California Regional Water Quality Control Board Central Coast Region

CALIFORNIA WATER CODE SECTION 13267 REQUEST FOR REPORT, HWY 58 AREA PROPERTY, SAN LUIS OBISPO COUNTY

REVIEW OF STORM WATER POLLUTION PREVENTION PLAN; KELEGIAN RANCH PROPERTY; SANTA MARGARITA

NOTICE OF VIOLATION; STORM WATER PERMITTING REQUIREMENTS; KELEGIAN RANCH PROPERTY; SANTA MARGARITA; SAN LUIS OBISPO COUNTY

Photo 2 – Hay bale check dam in blue line creek, middle hay bale pushed downstream.

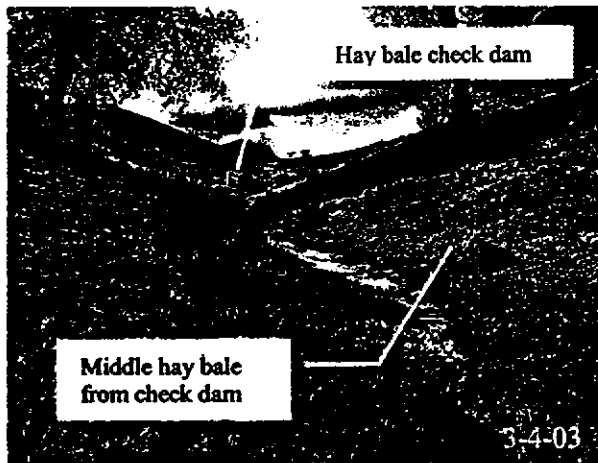
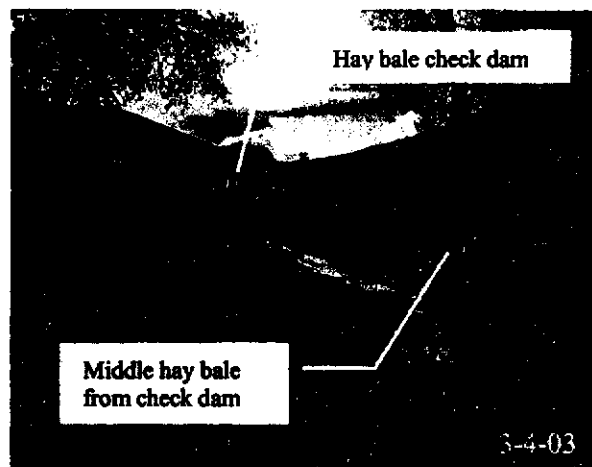
On March 4, 2003, Ryan Lodge and Jennifer Bitting of my staff inspected the Kelegian Ranch Property and found it in violation of the General Construction Storm Water Permit (Permit). While on site, Regional Board staff observed widespread erosion, and overwhelmed sediment control BMPs (Photos 1, 2). The nearby Huerhuero Creek and a nearby-unnamed creek are tributary to the Salinas River, which is currently listed on the Federal and Regional Board 303(d) List of Impaired Water Bodies for excess silt and sediment.

Photo 3 – Overwhelmed straw wattle in blue line creek.

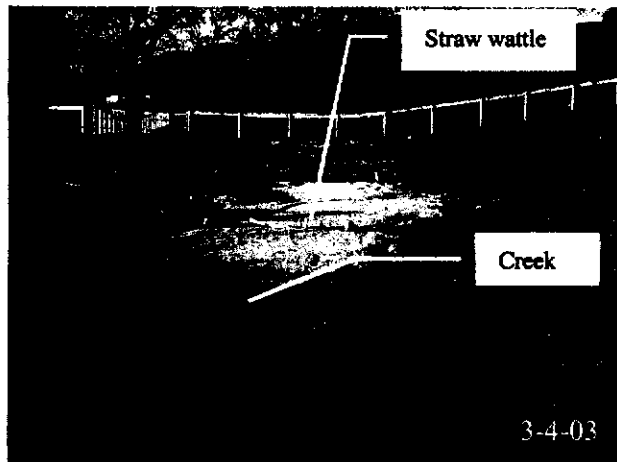
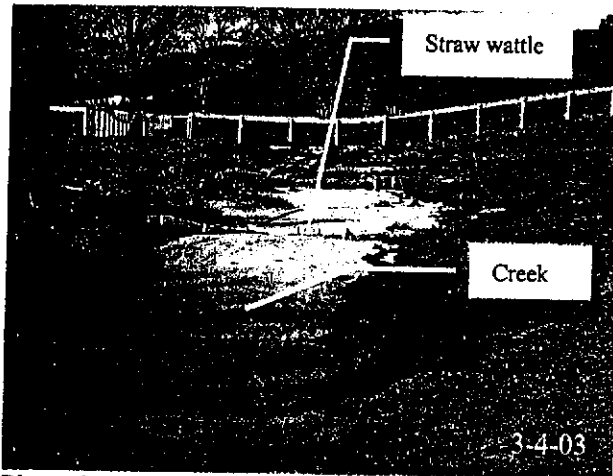
You have not installed straw wattles and enviroberm sediment controls as shown on the erosion control plan, or removed accumulated sediment from sediment control devices that are in place as outlined in your SWPPP. Sediment controls are ineffective once filled with sediment (Photo 3).

You have failed to implement an effective combination of erosion and sediment control as required by the Permit, resulting in surface water sediment discharges. You are required to install effective erosion and sediment controls to protect area creeks immediately. You have failed to implement a SWPPP in compliance with Part C.2 of the Permit. You must submit an updated copy of your SWPPP, with an implementation schedule by March 21, 2003.

Photo 4 – Sediment from hillside flowing into creek. The creek flows from right to left.

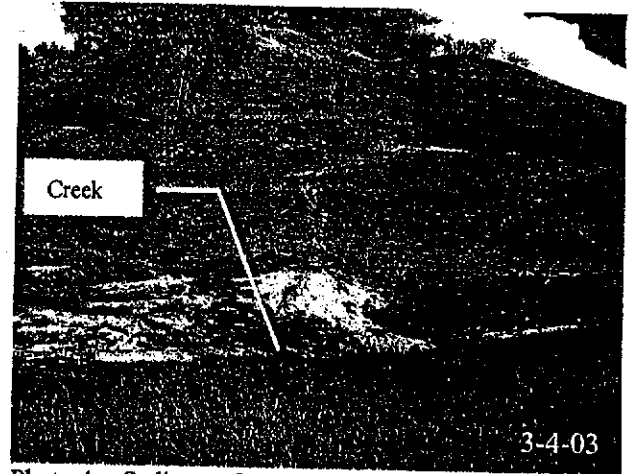
Site erosion resulted in sediment discharge into the unnamed tributary to the Huerhuero Creek (Photos 3, 4). Some sediment control measures were installed within the tributary creek. Hay bales and straw wattles installed across the directional flow of water are not BMPs. Sediment and erosion controls should be in place to protect the creek. Installation of sediment controls within the creek trap the sediment in the water body itself, which is detrimental to the creek.

Photo 1 - Sediment flowed into Huerhuero Creek.

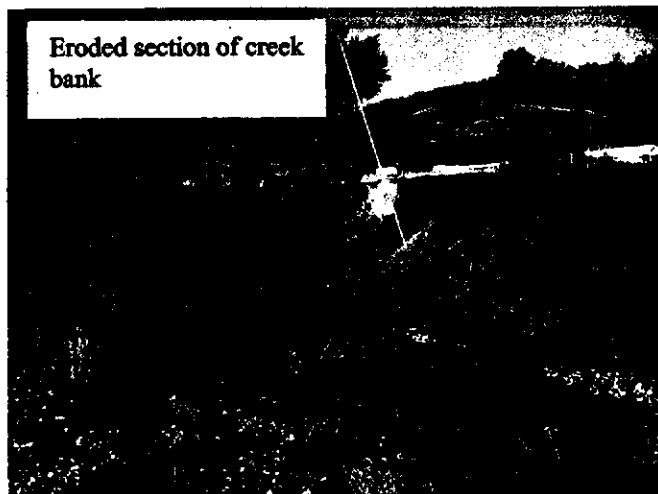
Erosion from the hills above the Huerhuero Creek resulted in sediment discharge into the creek (Photos 1, 2). Minimal erosion and sediment controls were in place to prevent sediment on the hillsides from flowing into the Huerhuero Creek.

Figure 1 Pierson property showing soil units with 7.5-minute quad background (Soil Map Units on the map correspond to Soil Map Units in Table 1)

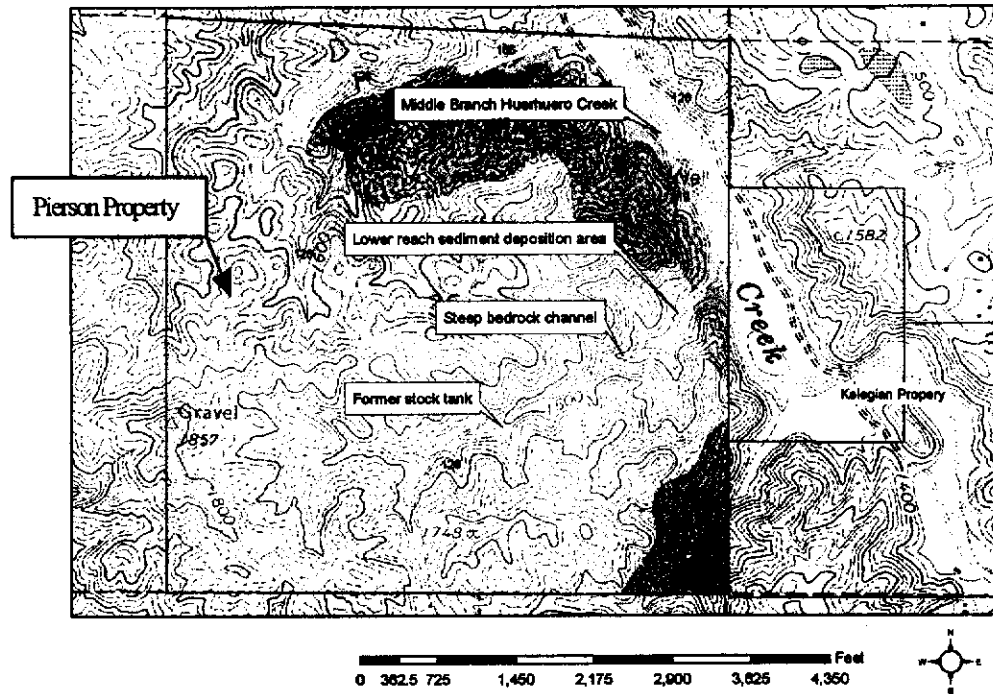
I evaluated portions of an unnamed tributary to the Middle Branch of Huerhuero Creek (see Figure 1). Sediment deposits were noted in the lower reach, two small side channels and in an area of a former stock tank. The soils in the grubbed area are primarily Cieneba coarse

Figure 10 Kelegian property showing soil units with 7.5-minute quad background (Soil Map Units on the map correspond to Soil Map Units in Table 2)

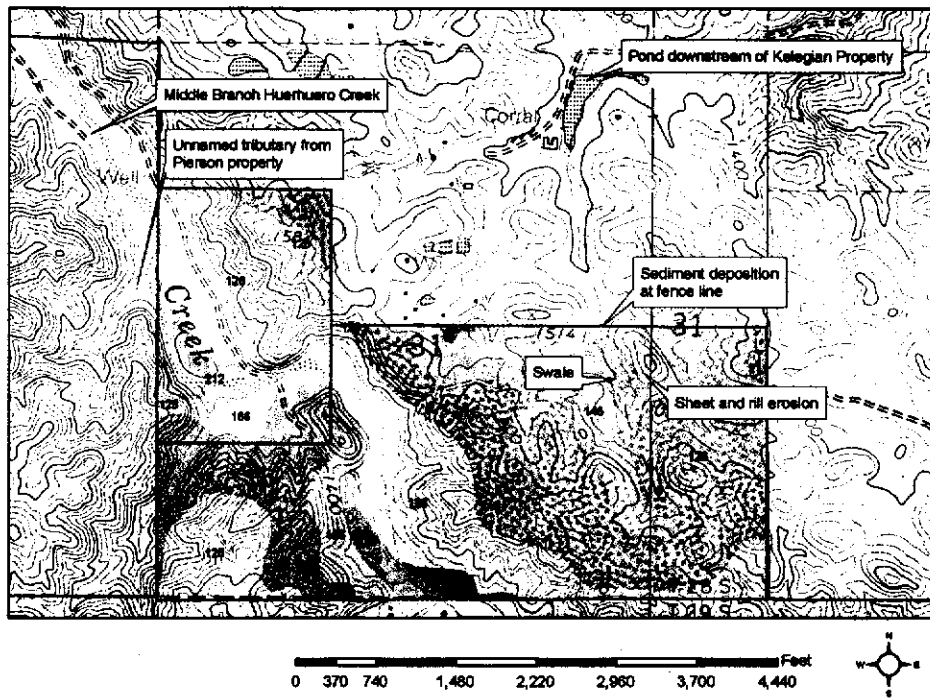
I observed sediment deposits upstream of the fence (see Figure 11) located along the property line. It appears that organic matter was lodged against the fence and acted as a fairly effective barrier to sediment transport. Very little sediment was noted on the adjacent property north of the fence. The sediment deposit is fan shaped with the base located along the fence with a width of approximately 35 feet. The sediment deposit extends uphill from the fence approximately 300 feet (see Figure 12 for upper extent of deposition). Small areas of sediment deposition were observed in the swale above the larger deposit shown in Figure 11 and Figure 12. An example of the grubbed area upstream of the swale, as it appeared prior to revegetation is shown in Figure 13.
